ADDENDUM DESIGN STATEMENT

Change of Use to Upper Floors and Alterations
to create 46 Bedroom Hotel

1-3 York Street, Manchester

Fig 8: LEFT extract from rear elevations drawing; RIGHT detailed section through sash windows.

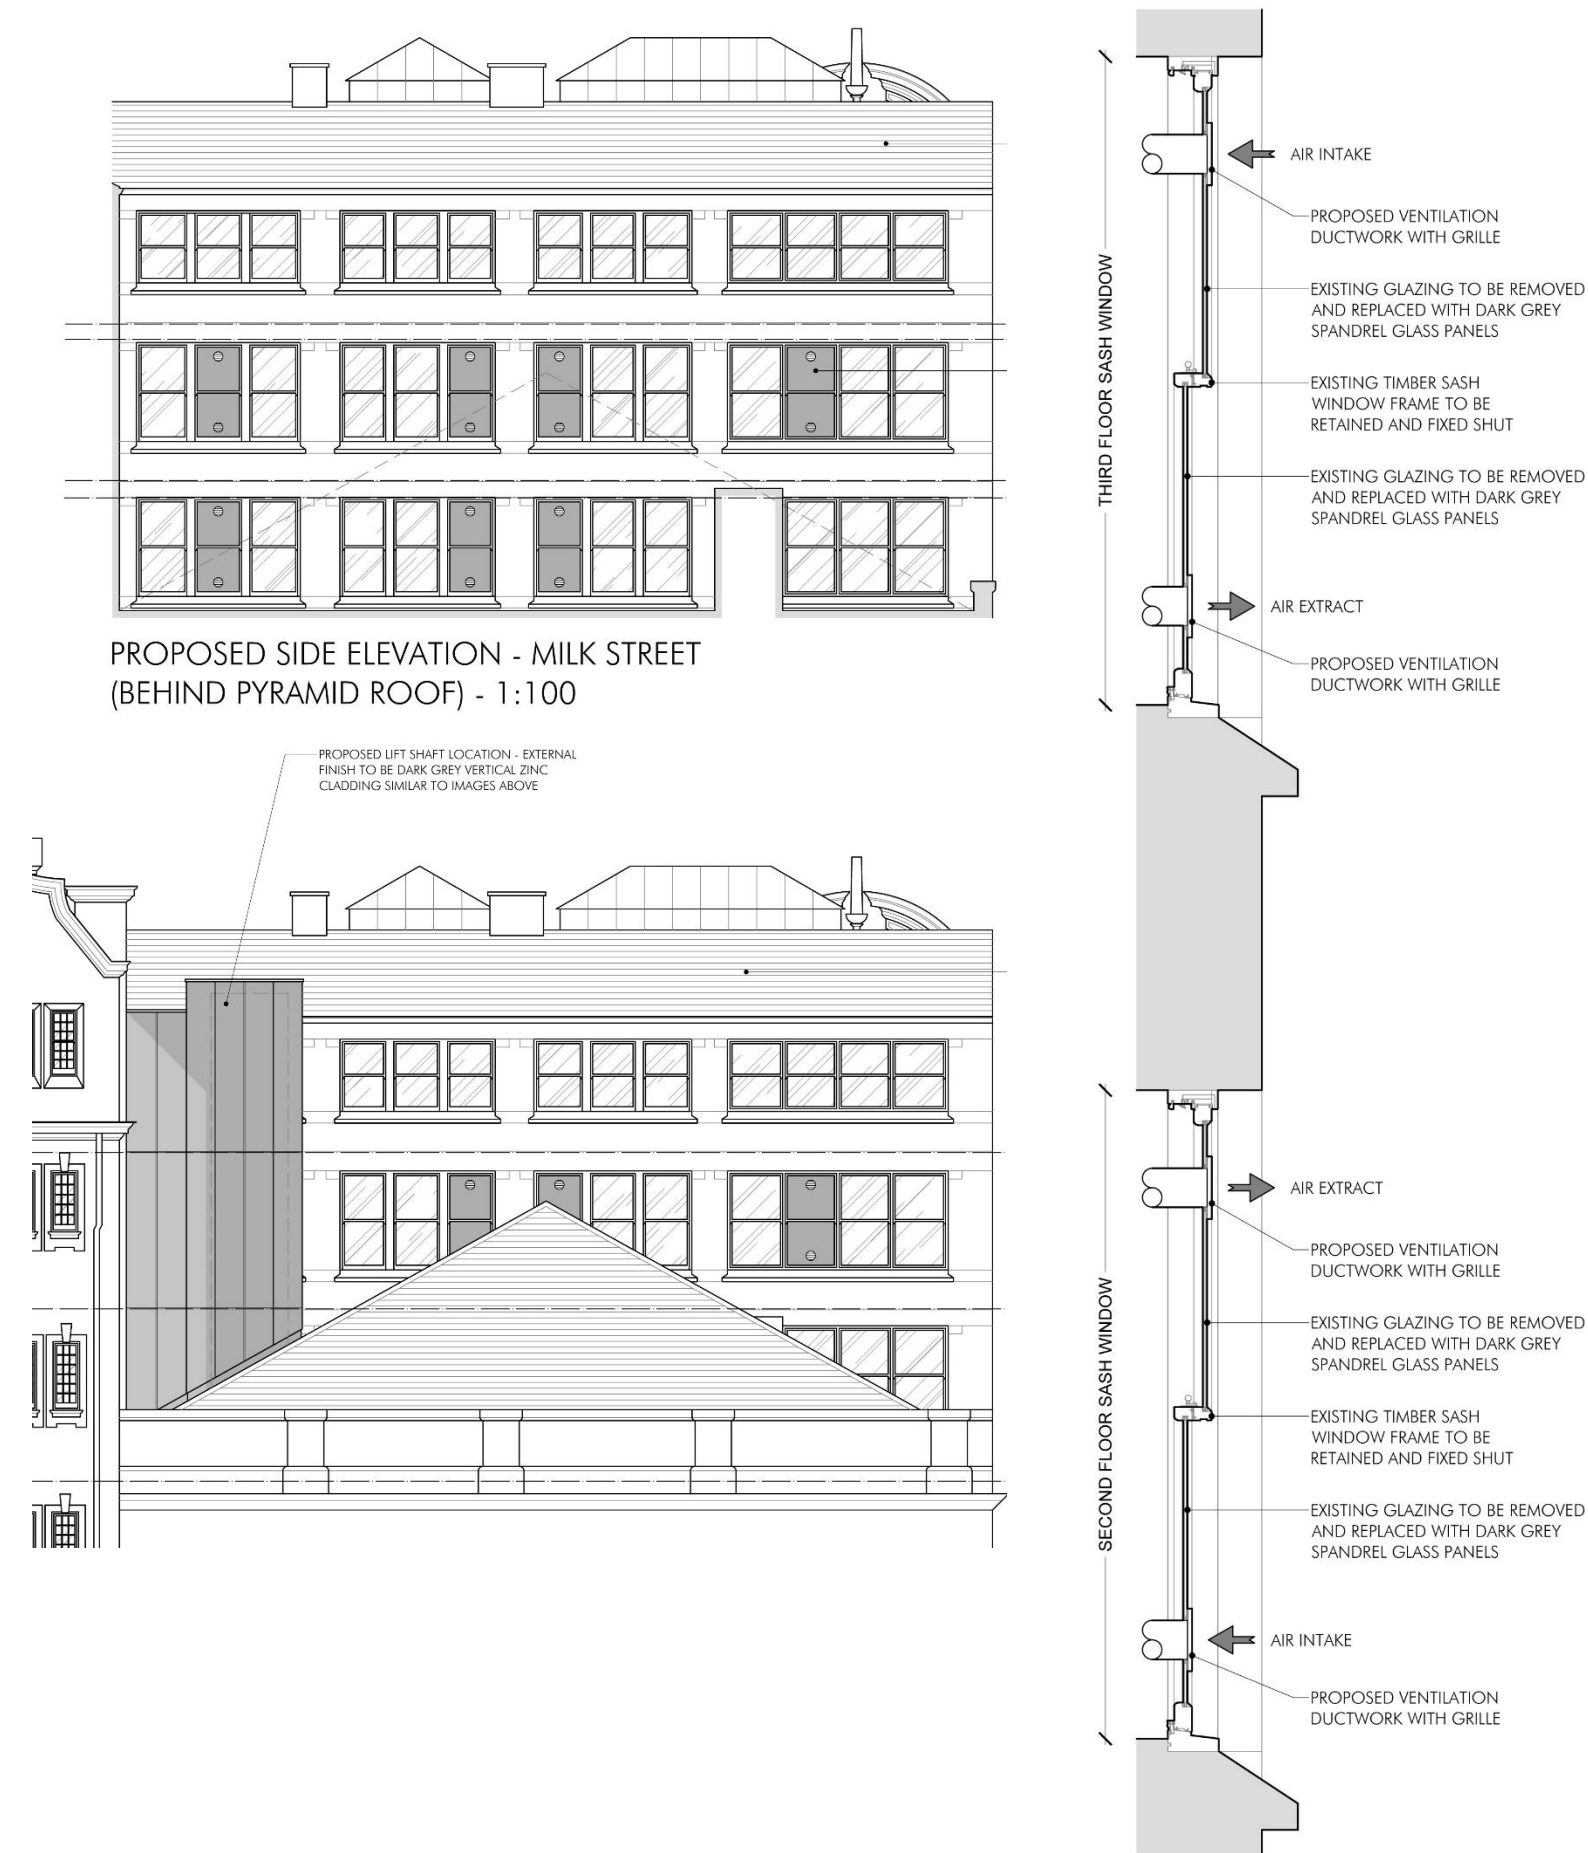
Following a site meeting with the planning Case Officer, it was established that the preferred method of ventilation to the rear bed/shower rooms to 2nd and 3rd floors is to take individual vents through window panes in order that this change is readily reversible. Each room requires an input and extract air vent which must be spaced apart by at least 1 metre to avoid undesirable re-circulation of exhaust air. The upper floor can be directly vented through the roof space. There is limited roof void space to accommodate a central ventilation system for these rooms – preference has been given to providing a central extraction system to the front façade where it is not possible to provide direct façade ventilation without a detrimental visual impact.

In order to achieve the required ventilation within the window panes with minimal visual impact to the rear, we are proposing to re-glaze the existing sashes with an opaque grey ceramic spandrel glass, with individual cut-outs for single air vents. As before, the affected windows are entirely obscured from view at street level by the courtyard pyramid roof, and mostly obscured by the pyramid roof when viewed from the adjacent office buildings. Using a glazed-in method, the existing sash windows can be retained or refurbished and the impact on the building fabric is limited and easily reversible.

Fig 9: LEFT The only record photograph of the former clerk's hall, from The Builder's Journal 1907; RIGHT photograph taken looking across the current ceiling void showing only the timber primary ceiling structure still in place.

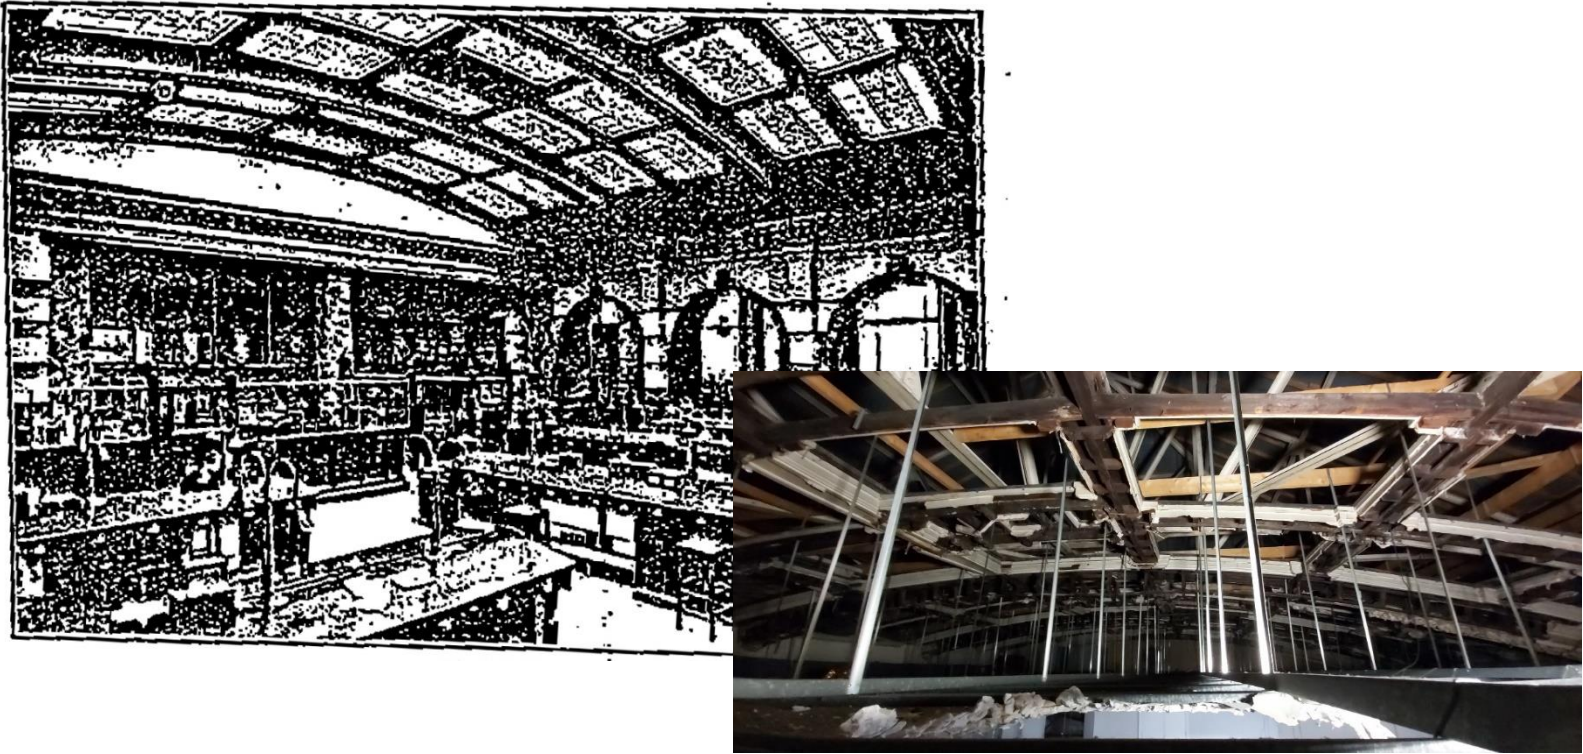
During consented alterations in the 1980s, the glazing to the former Clerks' Hall was stripped-out and a new plasterboard ceiling suspended from the primary roof structure above it. Some limited areas of glazing remain at the edge of the ceiling, however these are also punctured by metal strap hangers supporting the plasterboard ceiling below.

Fig 10: the proposed lift location (purple) in relation to remaining section of ceiling glazing (part reflected ceiling plan)

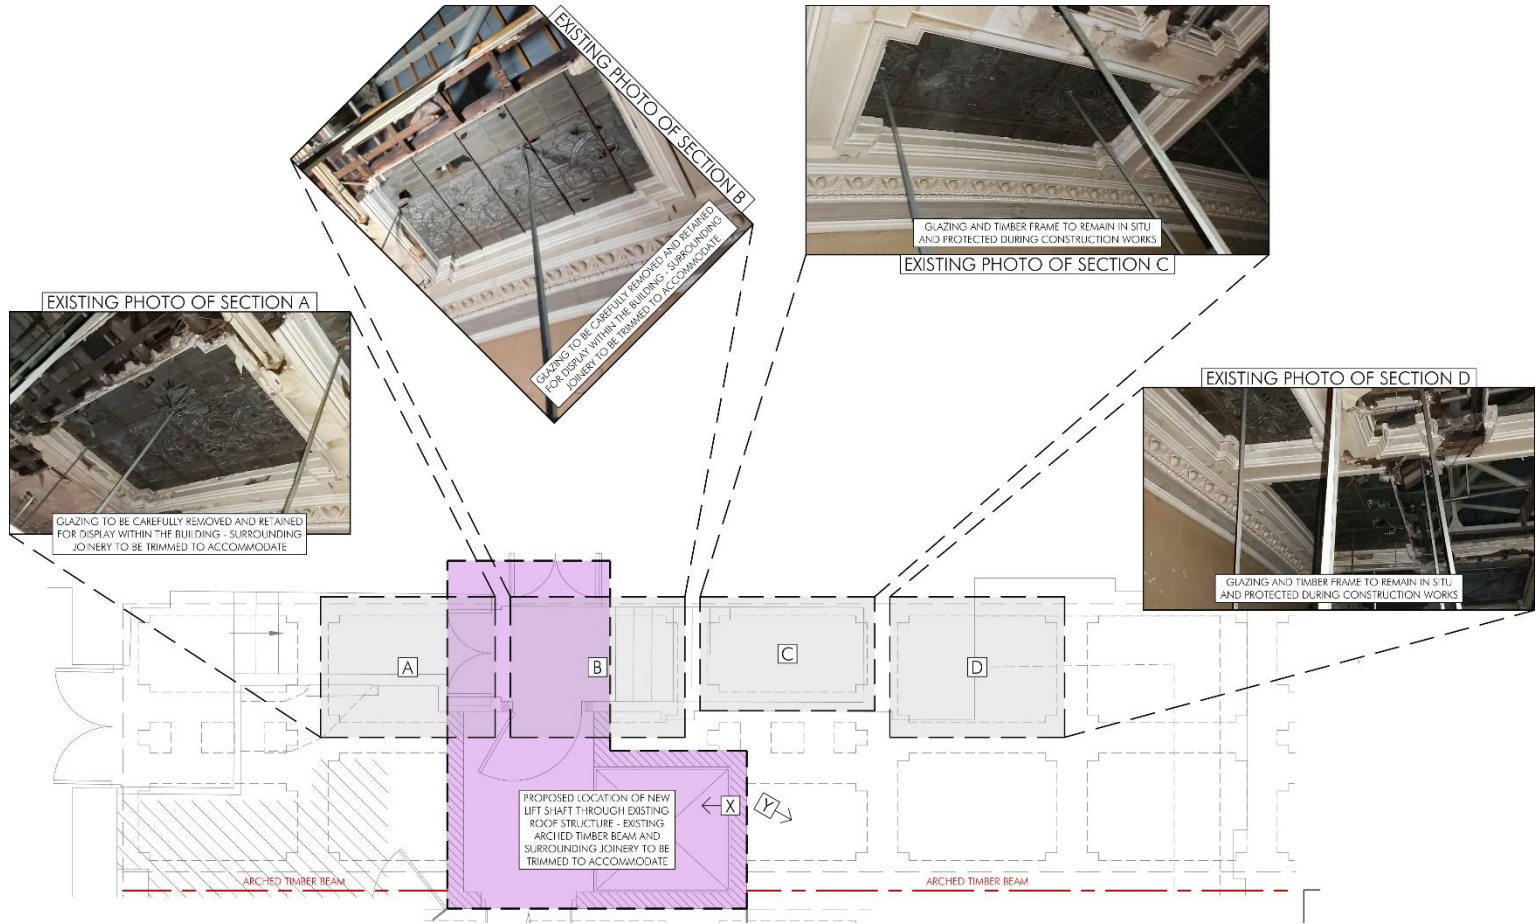
When inserting the necessary service lift for hotel use, its location is governed by the existing roof structure – a combination of steel and timber roof construction. The necessary location of the new lift is shown in purple on the illustration opposite. This location conflicts with the remaining small areas of glazing. Therefore we propose to retain two of the panes insitu, to be protected during construction; and we propose to carefully remove the other two panels for specialist conservation repairs and cleaning. The two restored panels shall be displayed in the public areas of the hotel – for example in the main stairwell on a landing between ground floor and reception – along with some information/interpretation. The panels can be back-lit as a wall feature or mounted in the ceiling – the final detail for this installation can be agreed by Planning Condition if required.

Fig 11: Rear building elevation (from Milk Street), showing side of proposed new service lift.

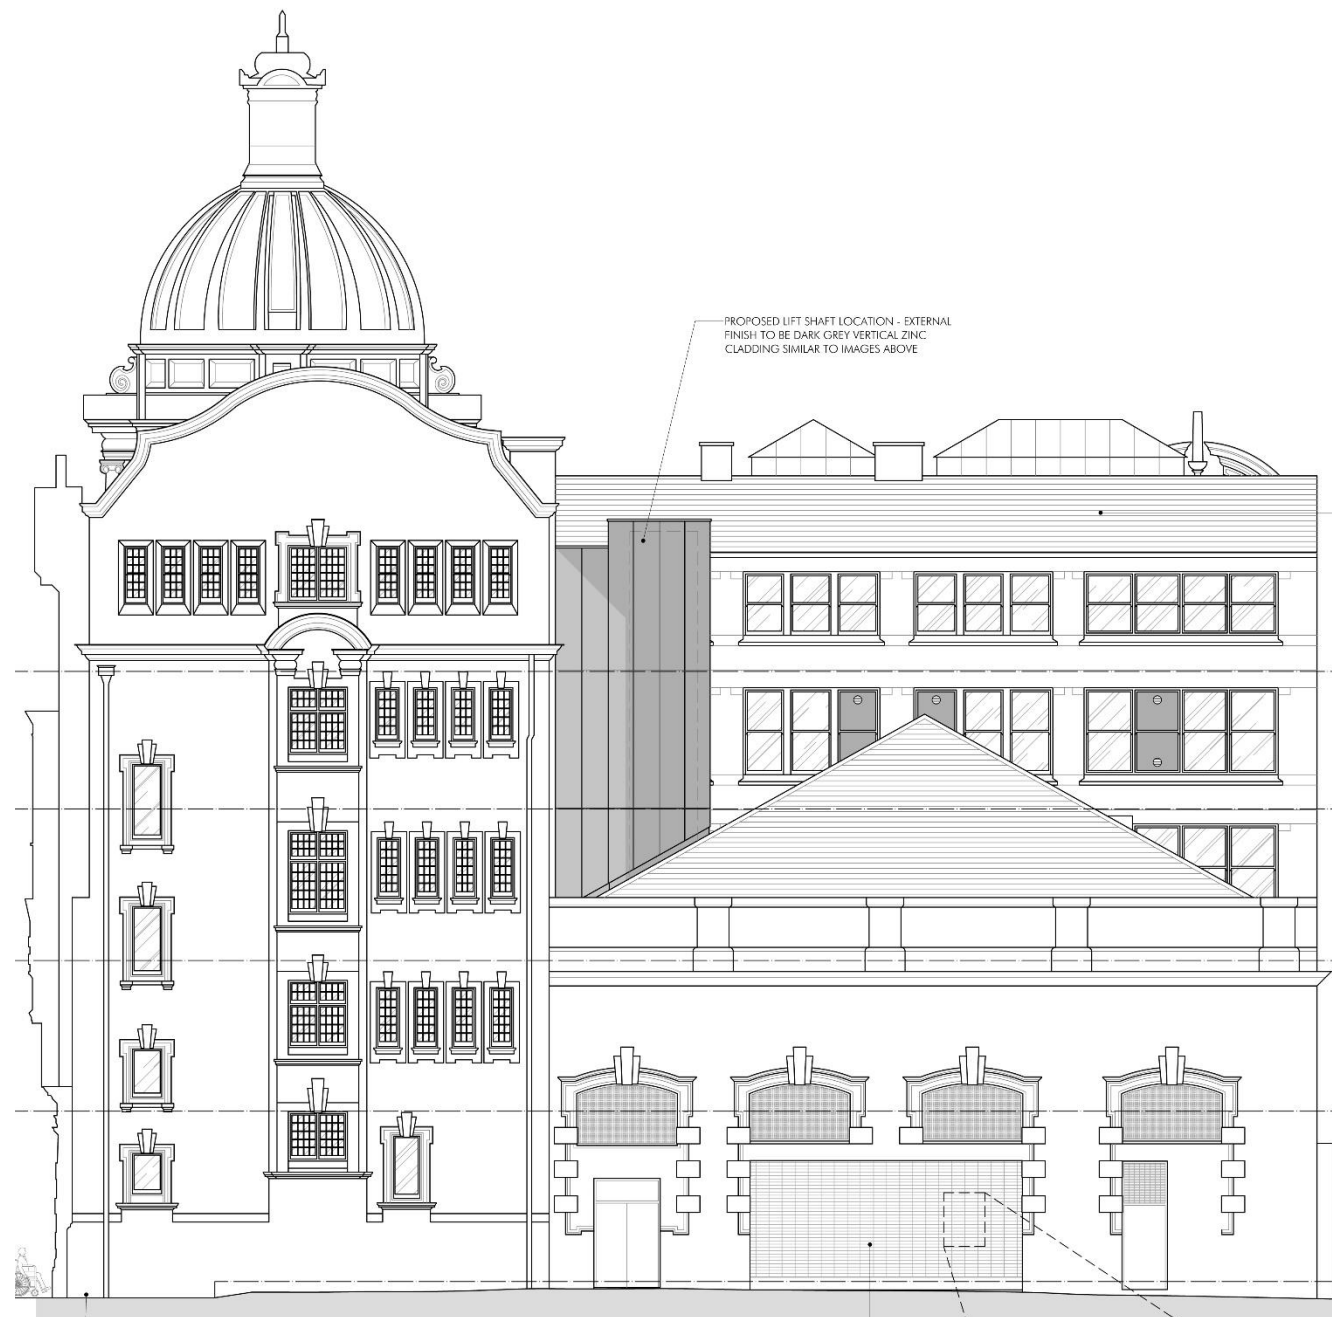
Although not formally noted, on separate site visits both the Conservation Officer and Planning Officer noted that the proposed timber cladding to the new lift shaft would be better suited to a material with longer lifespan than the timber cladding illustrated. Therefore we have amended this to be clad in a seamed zinc cladding in a very dark grey/black finish. This material is both sympathetic to the listed building and also contrasts - making clear the new intervention.
